HOUSE EXCHANGE SYSTEM.

UNIT TRANSFER INTERCOM. No. 2. (Q(L) 232)

MODIFICATIONS TO PROVIDE VISUAL ENGAGED SIGNALS ON EXCH. LINES.

Q(L) 234

WIRING MODIFICATIONS FOR VISUAL ENGAGED SIGNALS

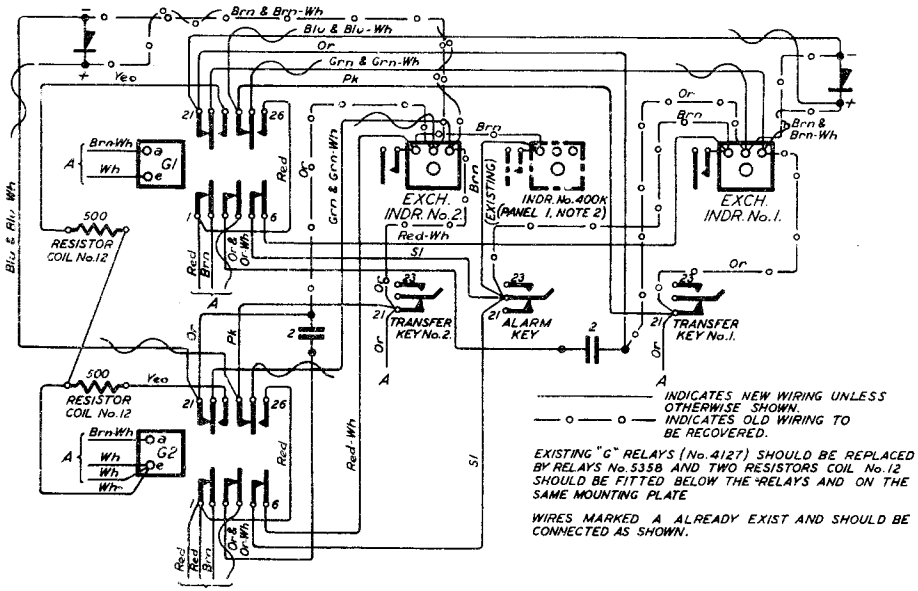
4. FOR PARTICULARS OF ADDITIONAL APPARATUS REQUIRED FOR VISUAL ENGAGED SIGNALS, SEE NOTE ON PANEL 4.
